4TH STREET SEWER REHABILITATION BID #13/14-019 – PWP# WA-2014-165

This addendum is to notify all potential proposers of clarifications made to the Bid documents as stated below.

Clarification of Dimensions:

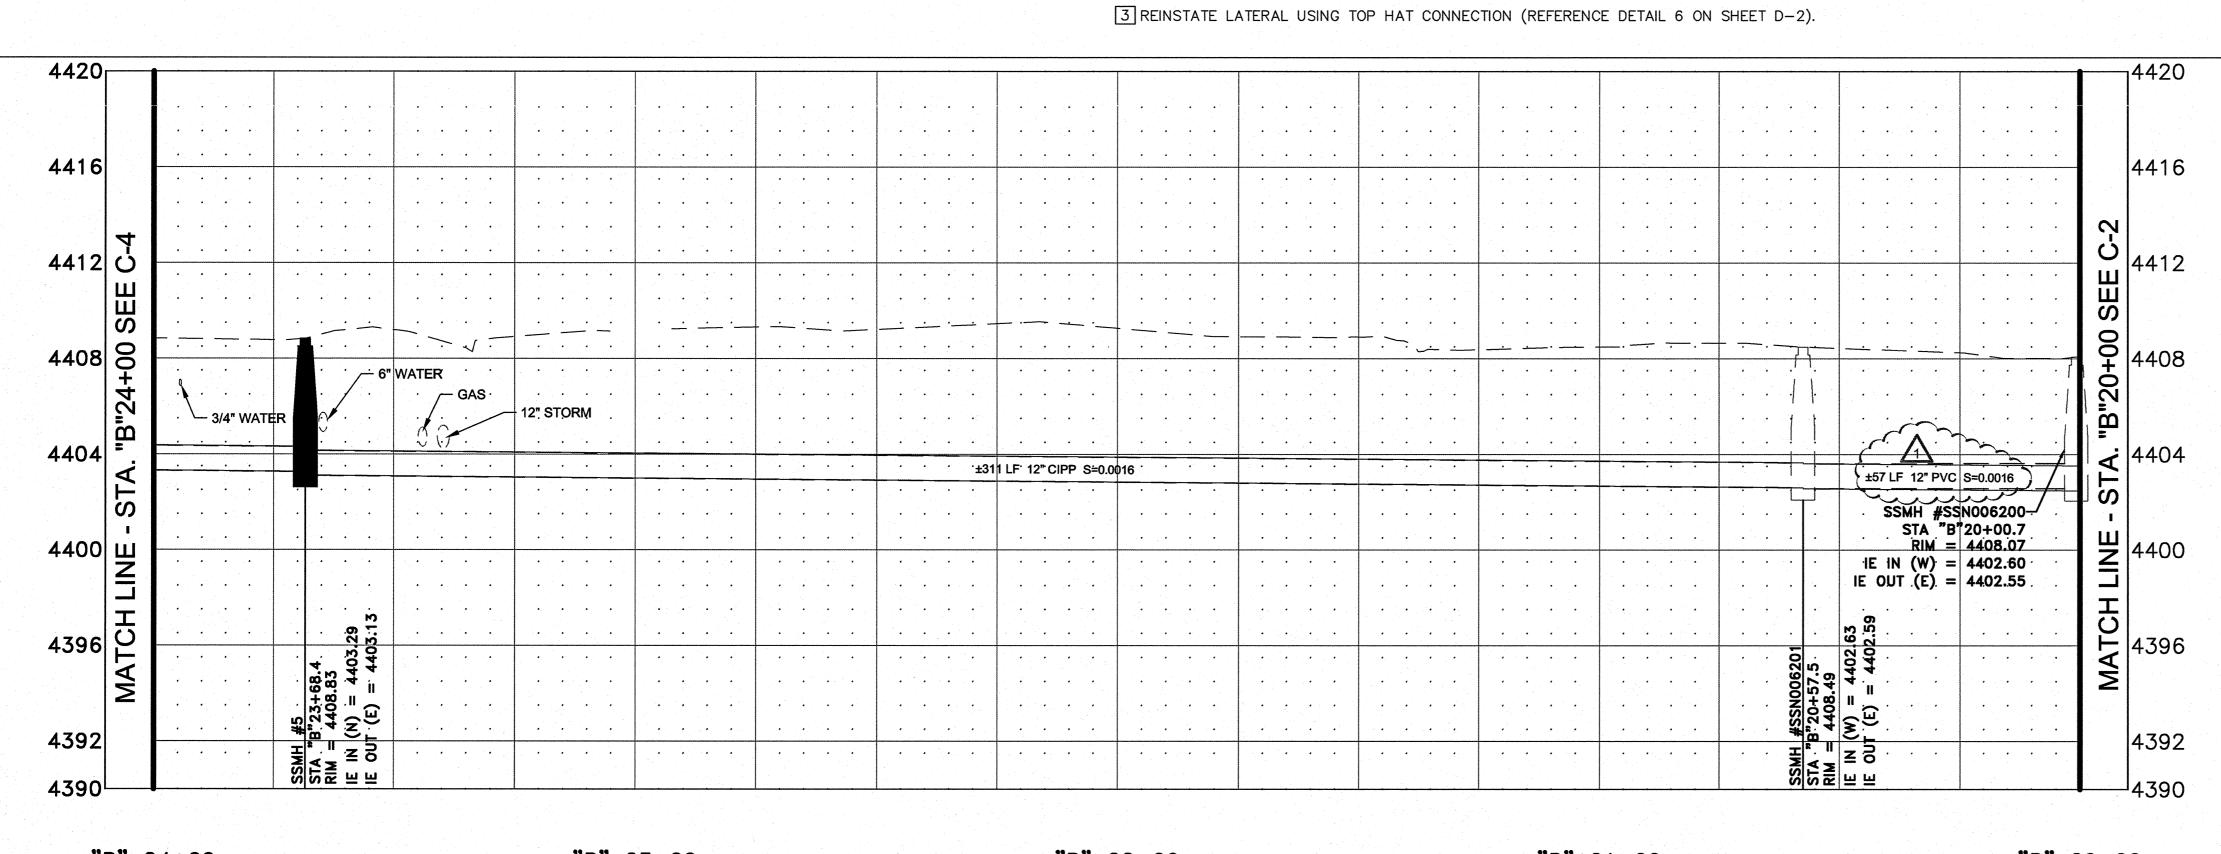
The labeled quantities (identified with a Delta 1) on revised plan sheets C-2 and C-3 (following this page) are clarified to correspond with the pipe segments. The total plan and bid quantity of CIPP Liner does not change for the project.
